**HATFIELD MCCOY REGIONAL RECREATION AUTHORITY
MCDOWELL COUNTY, WV
PROPOSED
ASHLAND RESORT TOURISM PARK DEVELOPMENT PROJECT
ADDENDUM #1**

**Monday November 9, 2020
Thrasher Project #030-10061**

ASHLAND RESORT TOURISM PARK DEVELOPMENT PROJECT

HATFIELD MCCOY
 REGIONAL RECREATION AUTHORITY
 ASHLAND RESORT EXPANSION
 McDOWELL COUNTY, WV
 SEWER PLANT PLAN

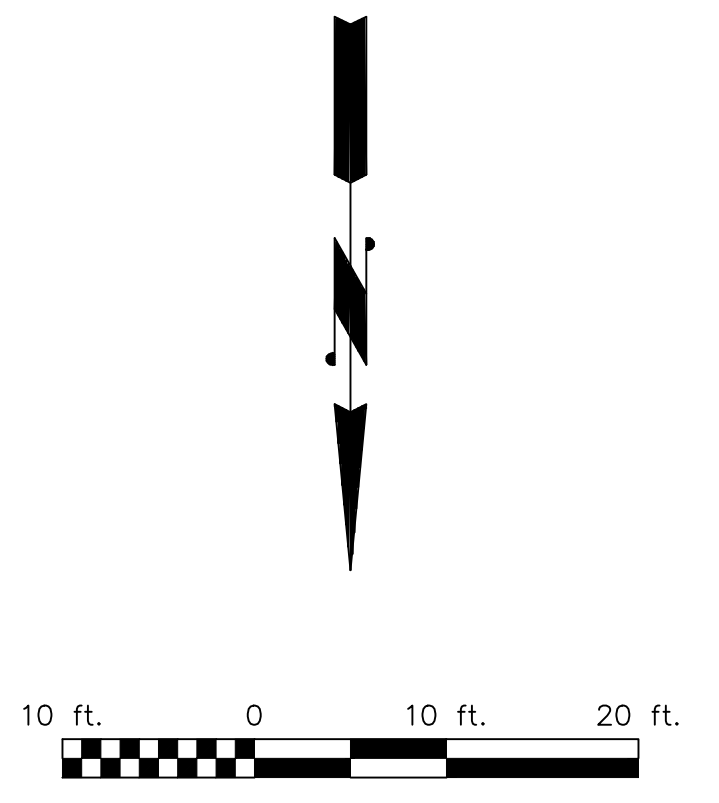
NOTE: IF DEDUCTIVE ALTERNATE #1 IS APPLIED, CONTRACTOR SHALL INSTALL 2" PLUG OR CAP PAST PLUG VALVE

1	PL	11/16/20	ADDENDUM No.1
1	SCB	11/7/20	ADDED DEDUCTIVE ALTERNATE LANGUAGE
NO.	BY	DATE	DESCRIPTION

HATFIELD McCOY
 REGIONAL RECREATION AUTHORITY
 ASHLAND RESORT EXPANSION
 McDOWELL COUNTY, WV
 ELECTRICAL SITE UTILITY PLAN

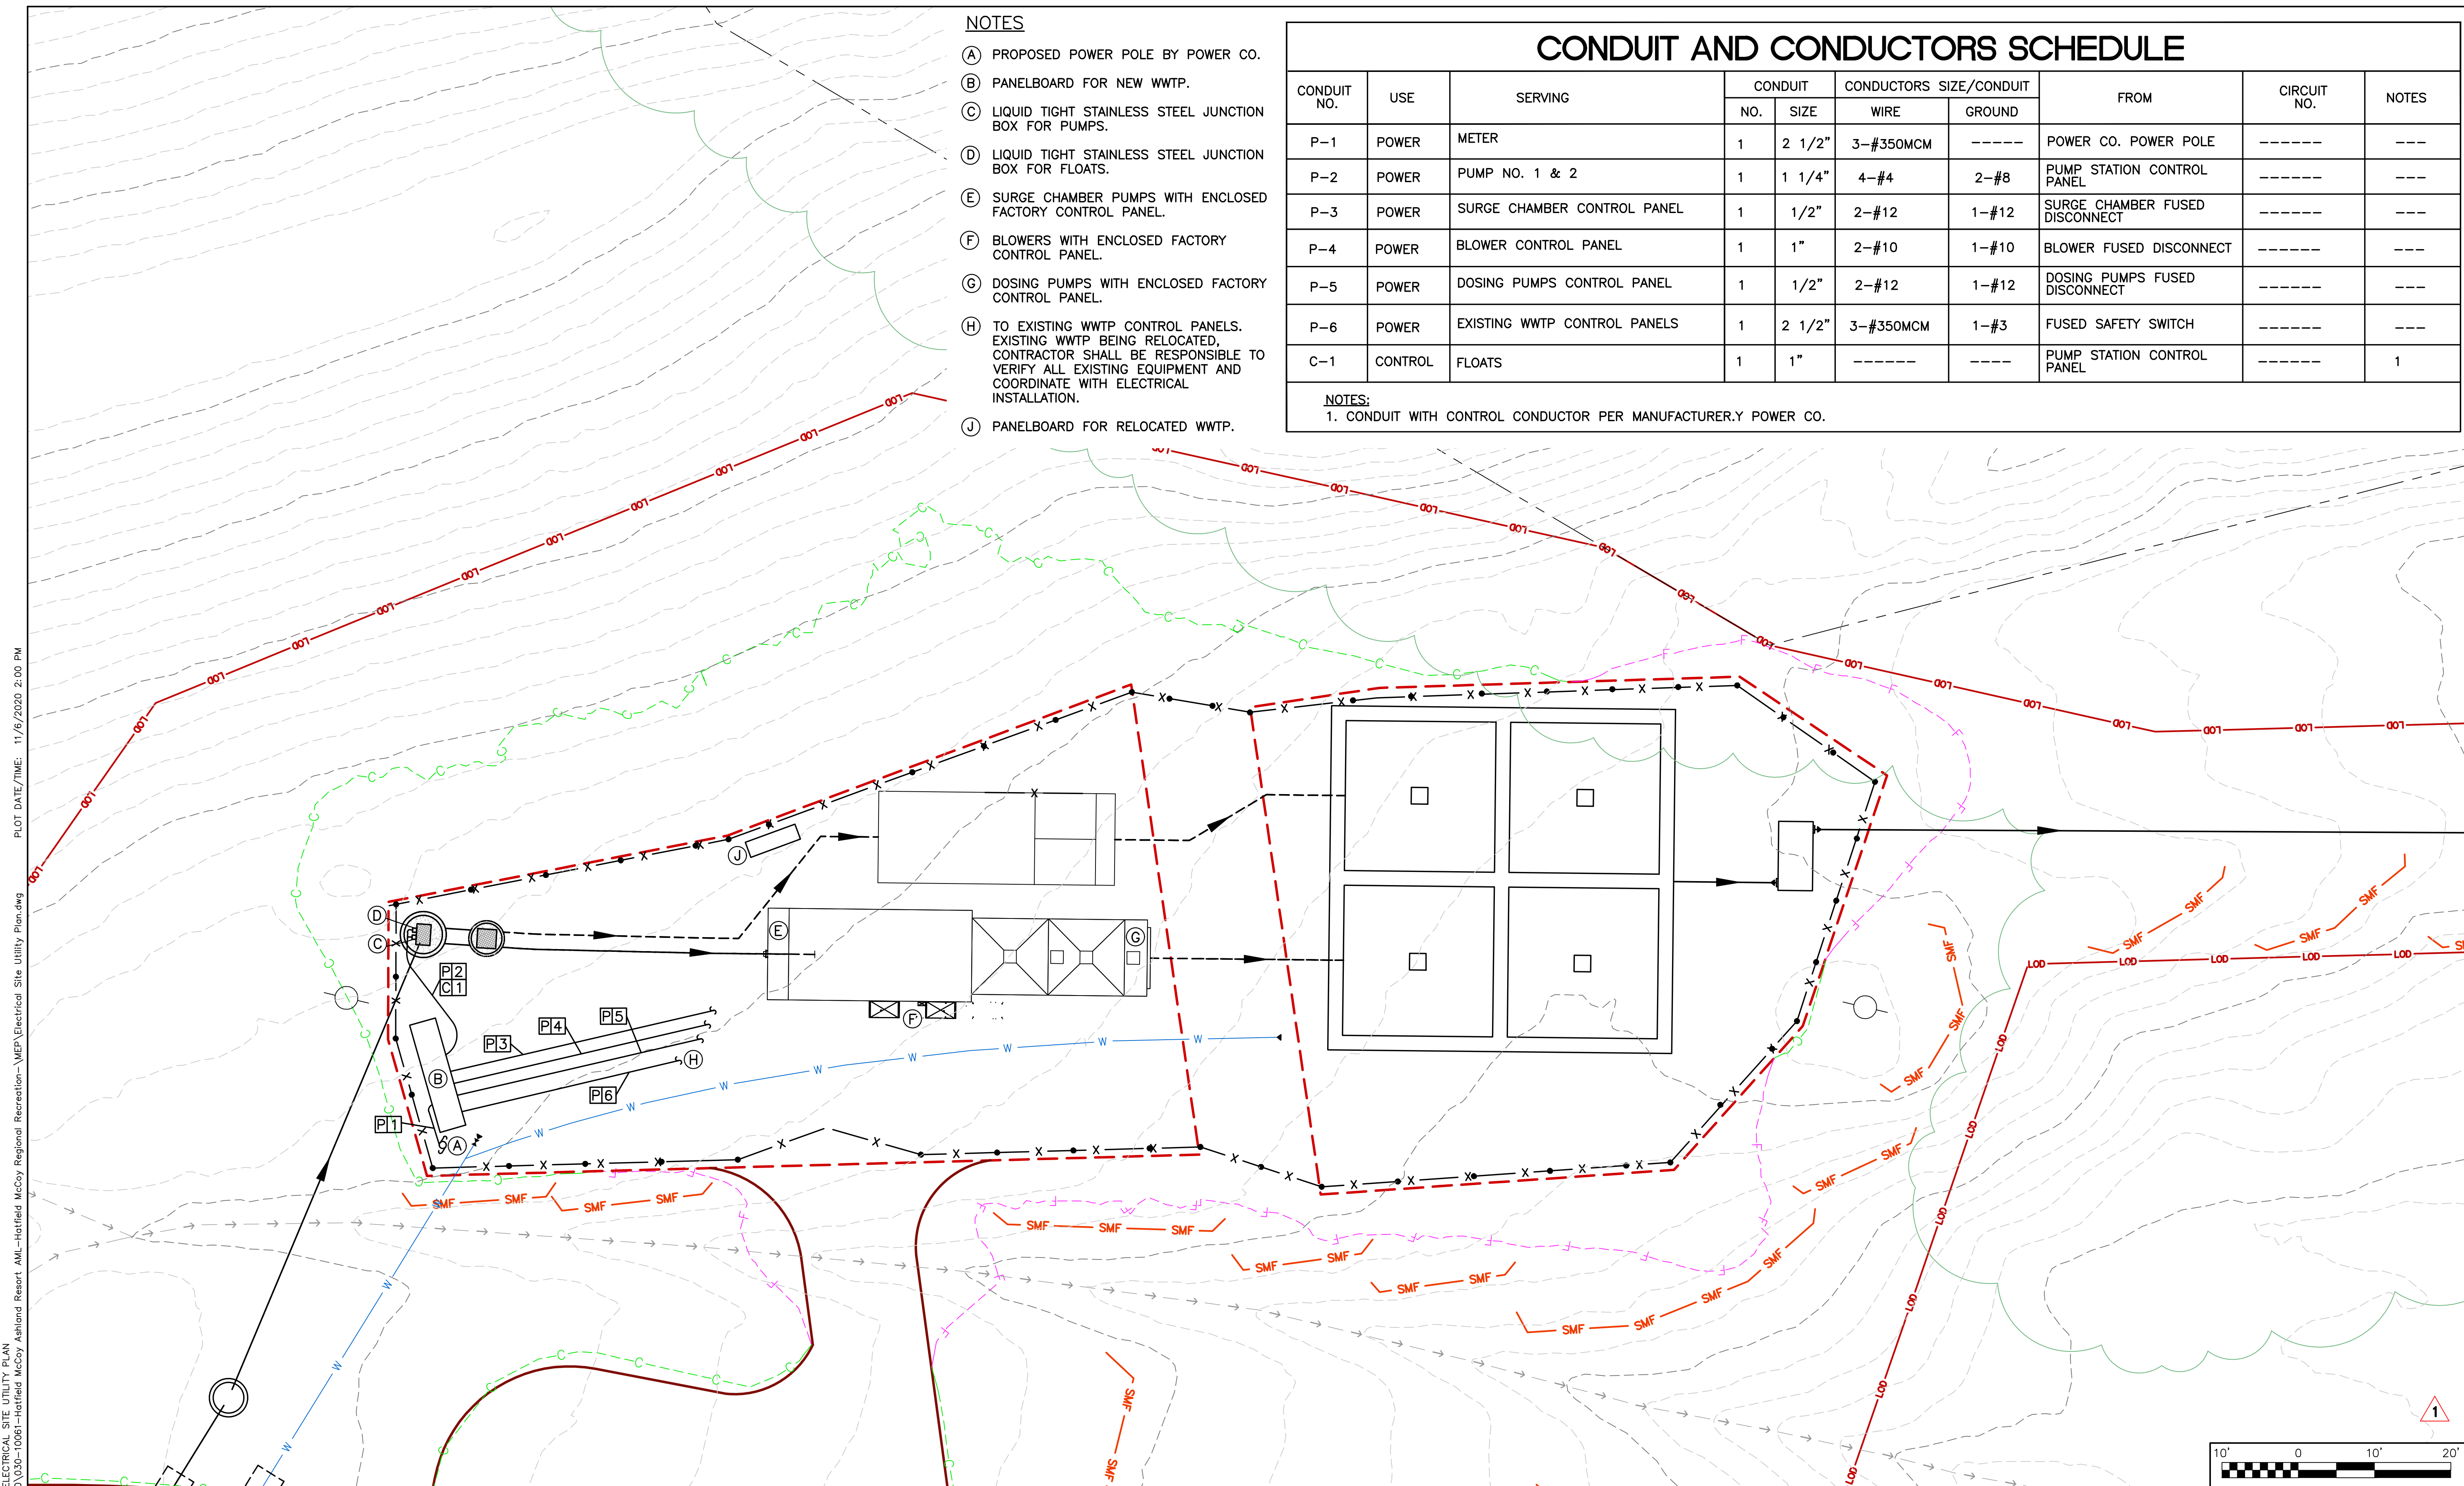
- 1. THE BID FORM HAS BEEN REVISED. YOU MUST USE THE REVISED BID FORM WHEN PREPARING YOUR BID PACKAGE FOR THIS PROJECT.**
- Electrical plans and details have been added to the plan set. See Sheets #E1 and #E2 of the drawings for clarification.
- A deductive alternate has been included to not remove and re-install the existing 15,000 GPD WWTP. A clarification of the piping for the WWTP has been included as part of this Addendum. Please see plan sheet #18.
- The warranty for both the Welded Steel Water Tank and the Bolted Steel Water Tank have been changed to 5 years. Please see technical specification 434111.00 section 1.12 and technical specification 434113.00 section 1.12 for the warranty changes.
